SERVICE PARTS LIST

BULLETIN NO.
54-26-1725

SPECIFY CATALOG NO. AND SERIAL NO. WHEN ORDERING PARTS		REVISED BULLETIN
1/2" D.I. IMPACT WRENCH		
CATALOG NO. 9071-20	STARTING SERIAL NO. 230A

RECALL NOTICE!

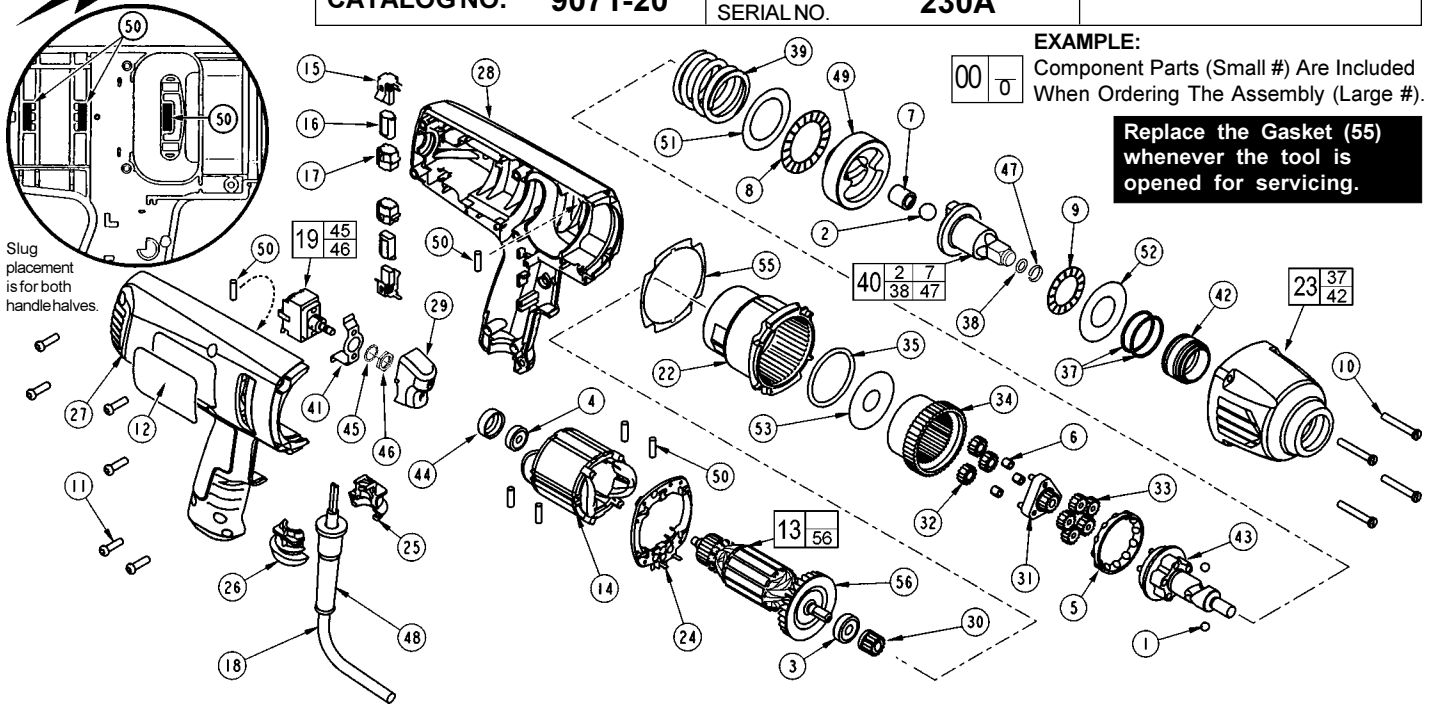
For operator safety a **9070-20, 9071-20 or 9075-20 Impact Wrench** within the listed serial number ranges **require original equipment 31-17-0265 Cord Clamp to be replaced with a 31-17-0270 Cord Clamp.**

As an aid to determining the cord clamp in a tool, the 31-17-0270 Cord Clamp has the numbers '**0270**' molded into the clamping rib. The 31-17-0265 Cord Clamp has no markings on the rib.

If the tool contains a 31-17-0265 Cord Clamp, please return your Impact Wrench to the nearest Milwaukee **factory** Service Center or Authorized Service station for no-charge warranty replacement of the cord clamp.

If nameplate has a '**X**' stamped into the tool's nameplate, next to the catalog number, the tool has been repaired and the defective cord clamp has already been replaced.
